CITY OF PORTAGE PLANNING COMMISSION

SUBJECT: An application seeking Site Plan approval for Oakland Apartments at 10506 Oakland Drive.

The applicant (Scott Oakland Drive LLC) has filed a Site Plan application for a proposed multifamily development at 10506 Oakland Dr., located at the SW corner intersection of Oakland Dr. and W. Osterhout Ave. The proposal consists of three, 2-story buildings, parking lot, and a variety of site improvements. Details of the project are provided later in this report.

SITE LAYOUT PLAN

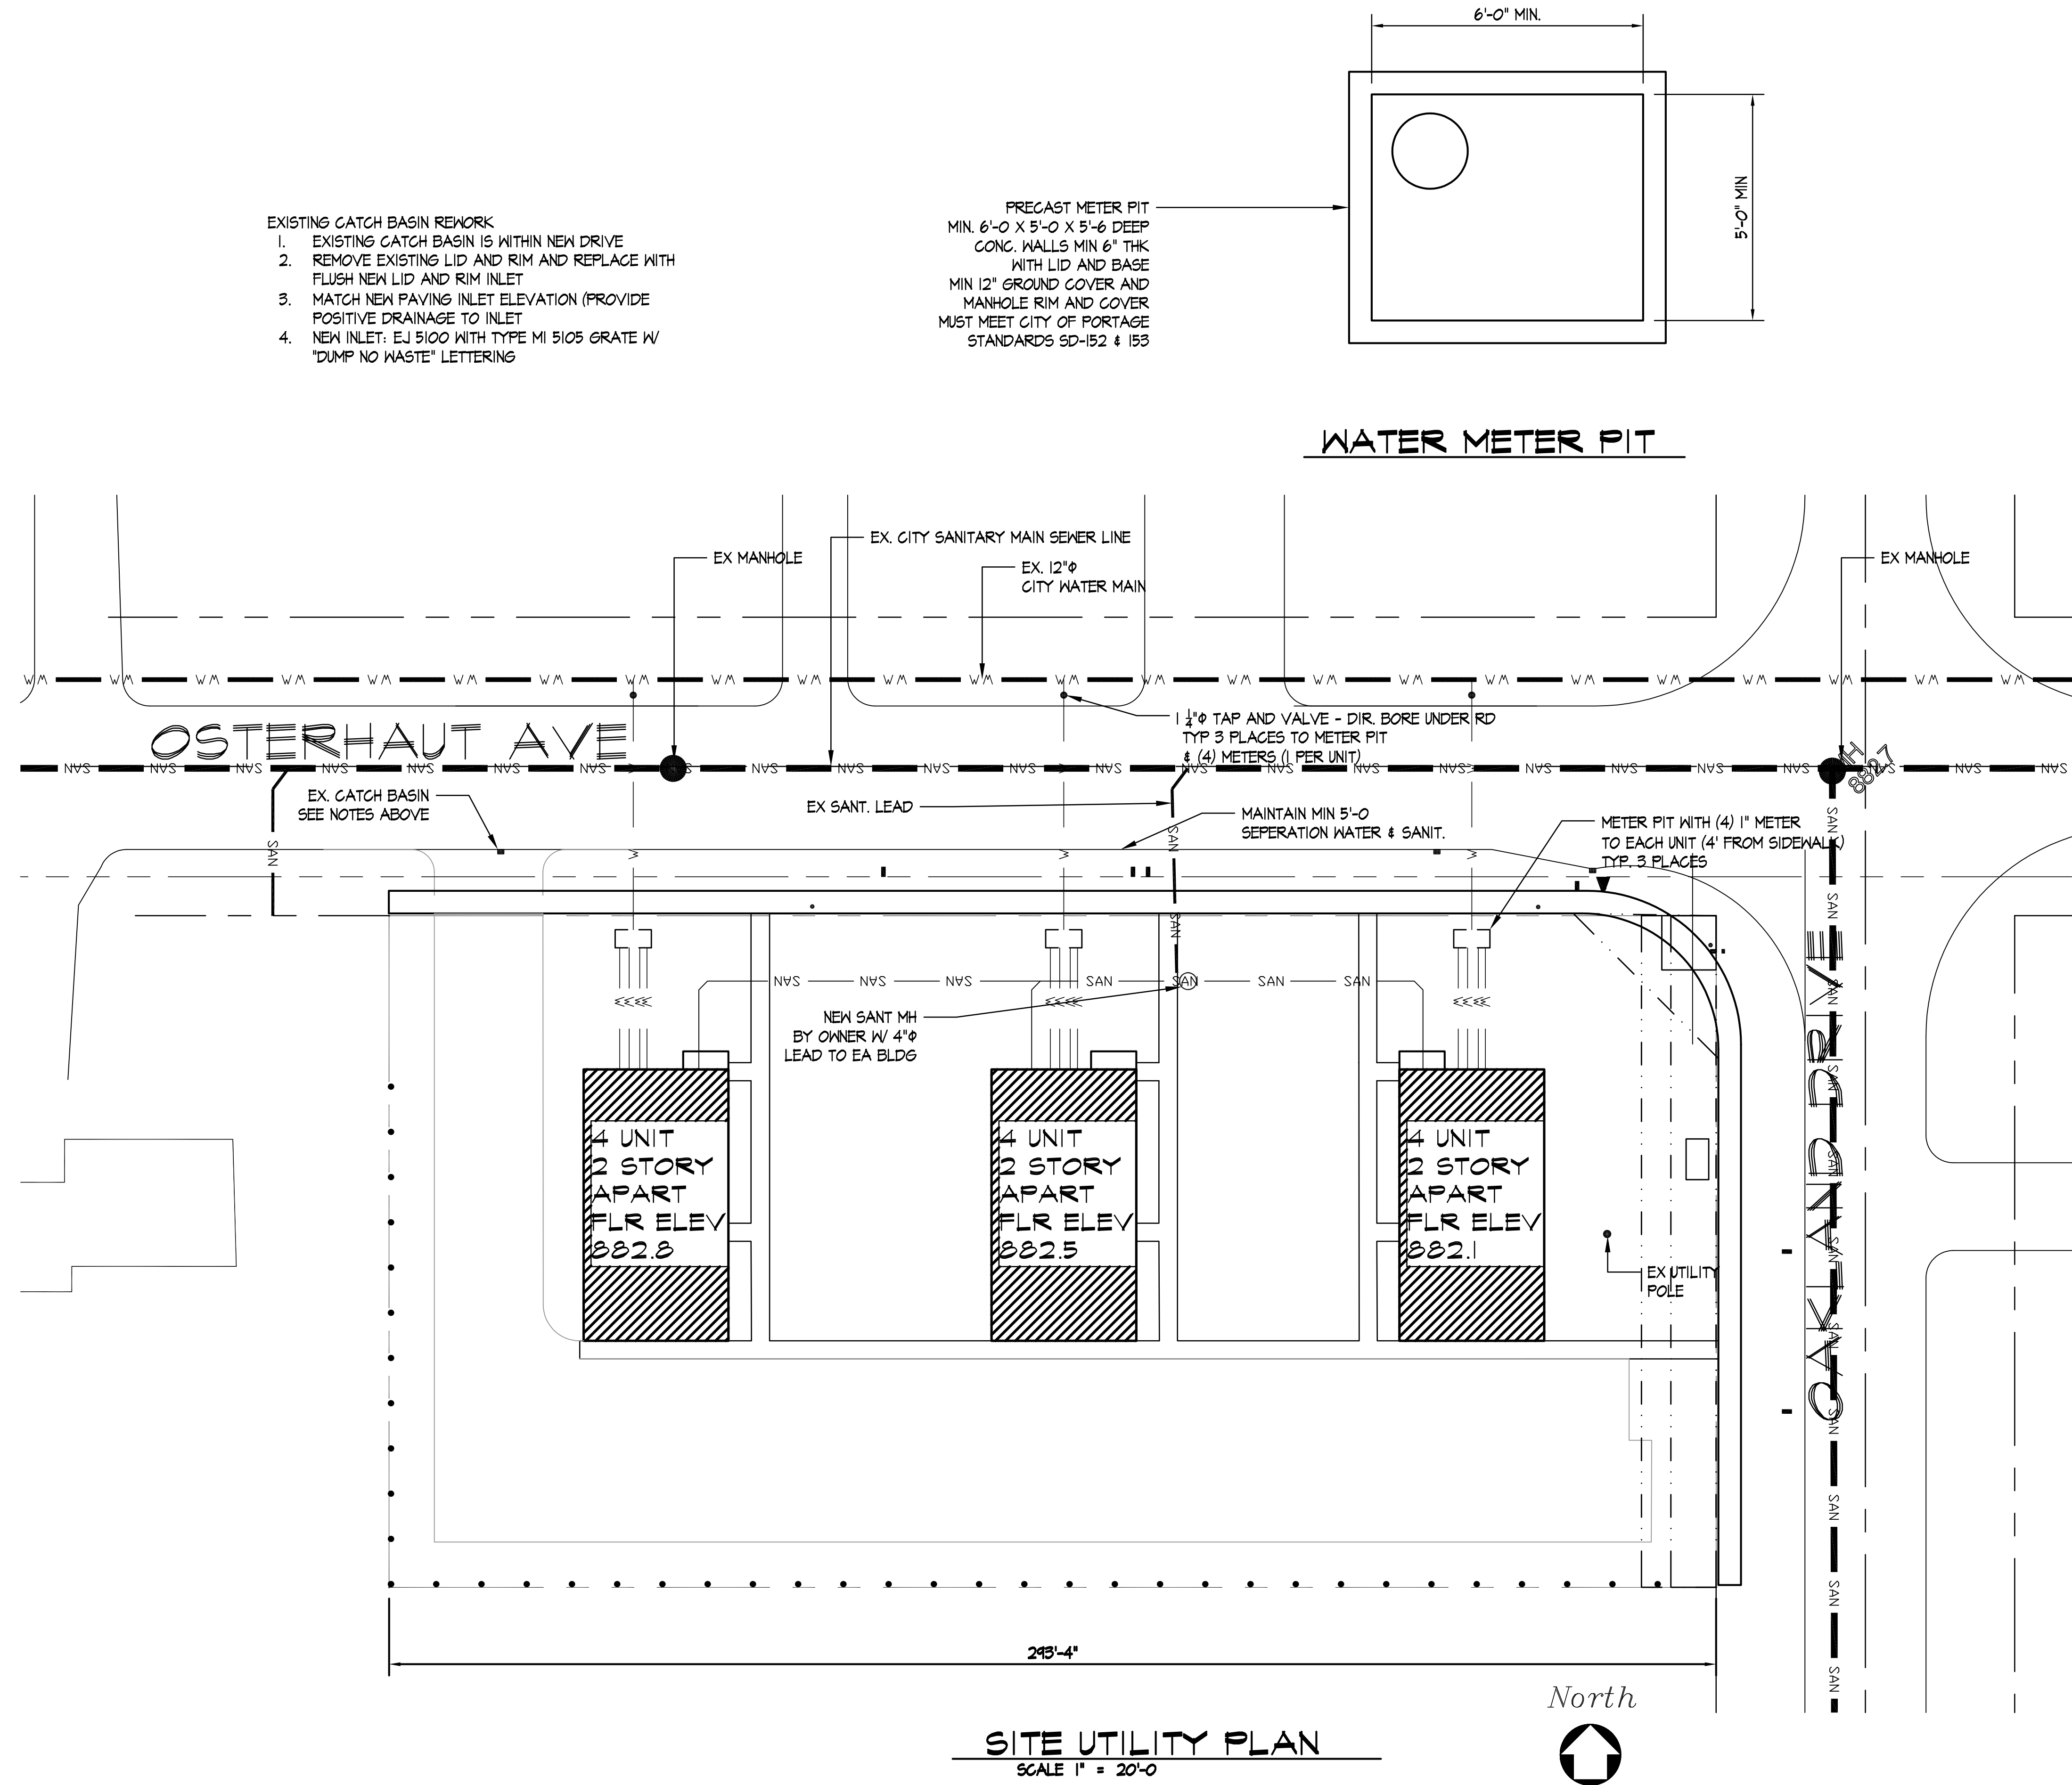
Staff received a letter from the owner at 2205 W. Osterhout Ave (to the west) requesting a taller fence from 6' to 8' along the shared west property line to provide greater screening from future apartment traffic, garbage truck, and other activity from the proposed development. The owner indicated that their house is 14'-15' away from the shared property line, and that the proposed fence is insufficient for screening. Staff discussed the project and fence with this owner and finds that the proposed fence is sufficient for general screening of any potential development impacts.

The property is directly adjacent to our property to the east. According to the proposed site plan that is not to scale with regards to the relative placement of our house, the fence will be approximately 14-15 feet away from the east side of our house. The proposed driveway will be approximately 10 feet east of the fence.

These proposed measurements will result in 18-24 vehicles driving in and out all day at a distance of approximately 25 feet away from our bedroom window. Not only is the disturbance from the vehicles a concern, there will be a garbage truck that will absolutely need to back up in order to exit the property after dumping the dumpster into the truck. The constant beeping noise of a garbage truck backing up at a mere distance of only 25 feet from our bedroom will be a nuisance. The truck will be free to come and go at any hour of the day as per Eric Feldt, Senior City Planner.

The proposed location of the dumpster is also within 50 feet of our bedroom in our house. The noise of a dumpster dumping into a garbage truck is certainly not quiet, and at such a short distance from our house, it would definitely cause a disturbance. At one point in the planning process, the proposal included individual garbage cans as opposed to a community dumpster, which would eliminate the nuisance of a garbage truck dumping a large dumpster and reversing with a constant beeping noise.
